Docket Item # 5
BAR CASE # 2007-0136

BAR Meeting
December 12, 2007

ISSUE: Addition and Alterations
APPLICANT: Saharat Prompol
LOCATION: 419 North West Street
ZONE: RB/Residential

Proposed East Elevation

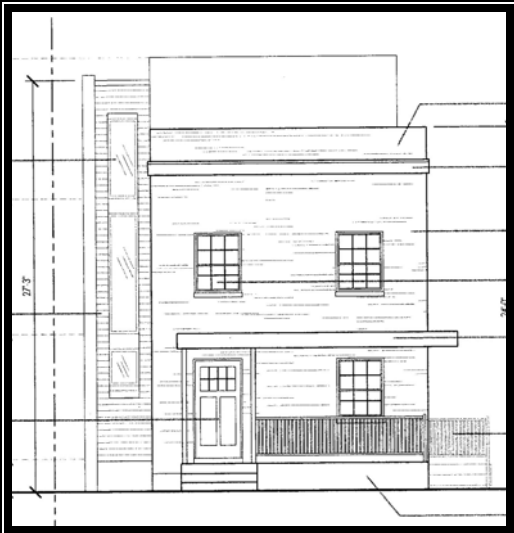
The east (rear) elevation will also be composed of two major blocks, including the taller stair tower component. The main two-story block will have a brick pier at the left side where it wraps around from the south side. Beyond this, it will have a narrow strip of wood siding and then a large expanse of glazing. There will be French doors and a large full length window on the first story. The second story will have the same, only the positions of the door and window will be the reverse of those below. The second story door will have a wood railing at the base. Two rectangular windows will be located above the second story window and doors, serving as a clerestory. The east elevation of the stair tower will match that of the west elevation with a long narrow window divided into two sections separated by wood panels within a wall clad in wood siding.

Proposed West Elevation

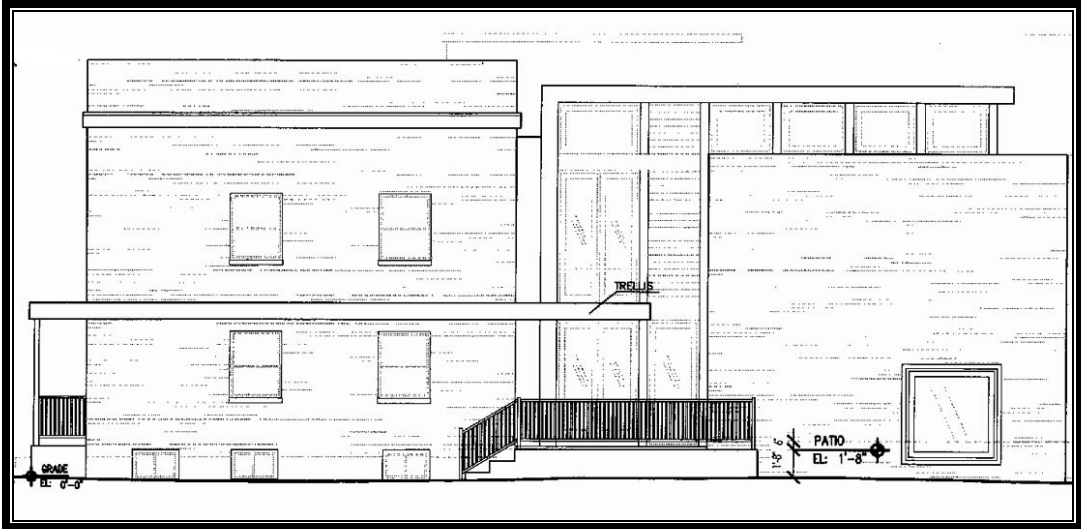
The main block of the addition will not project above the existing house as previously shown. However, the stair tower to the north will be approximately 1'7" taller than the existing house, with the addition of the 3' parapet. The narrow end of this two story rectangular block faces the west. It will be clad in wood siding and will have a long narrow window divided into two sections separated by a wood panel. On the south side, the addition has been pulled in even with the existing house and thus will not be as visible. The overhang, trellis and entrance steps to the addition will be visible on the south side.

Proposed South Elevation

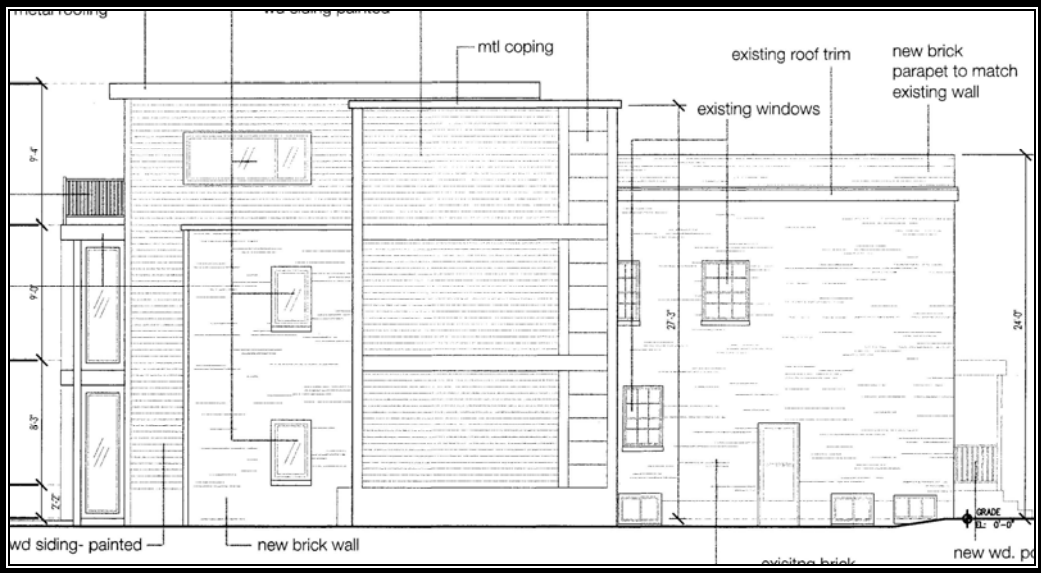
The addition will be composed of two primary sections on the south side and has been reduced to two stories, and maintains a flat roof (the prior iteration was three stories and contained decking on this elevation). In the forefront and toward the rear or east will be a two story brick block having a single, 5' by 5' square window in the first story at the east end. In the current design, this block is even with the plane of the existing house. In the first iteration, it had projected beyond it by 2'. The roof remains flat and the third floor roof deck has been eliminated. The connecting section between the existing house and the rear brick block will be taller, but also two stories, and contain more glazing. This section will be clad in wood siding and will have vertical trim strips defining the bays and horizontal strips defining the stories. A new entrance to the house will be located on the south side, accessed by a new brick terrace with wood railing and trellis over the entrance area. The door will be paired French doors with a full length window located to the right of the French doors, functioning as a sidelight. Paired long windows with wood panels below will be located in the second story directly above the entrance. There will be additional window groupings above, giving the appearance of a clerestory, with a single window above the second story paired windows, and four single windows located over the main brick block. The stair tower, located on the north side, will be visible above the existing main block and the new two story block. It will have a flat roof, no openings and will be clad in wood siding.

Proposed North Elevation

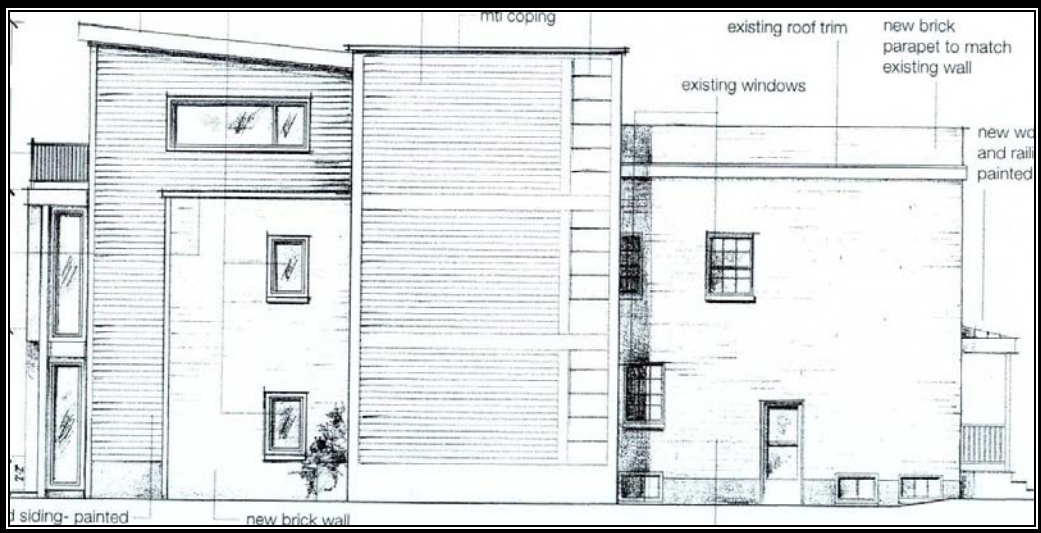
Again, the north elevation is composed of three sections: the story stair tower at the forefront, the two story portion of the addition set back 6'6", and the narrow sliver of two story addition at the east end. The 16'2" wide north wall of the stair tower section will be without openings (this had been 17'7" wide in the last iteration). It will be clad in wood siding with a narrow strip of wood panels at the west end. Horizontal wood trim strips will define the three sections. Beyond this will be the two story addition which is broken into two fields, one clad in brick and one in siding. There will be a window in each story. A rectangular window will be located in the first and the second story near the west end of this section. On the same plane but not as tall is a narrow two story section that is almost entirely glazed, consisting of a full length window in the first and second stories.
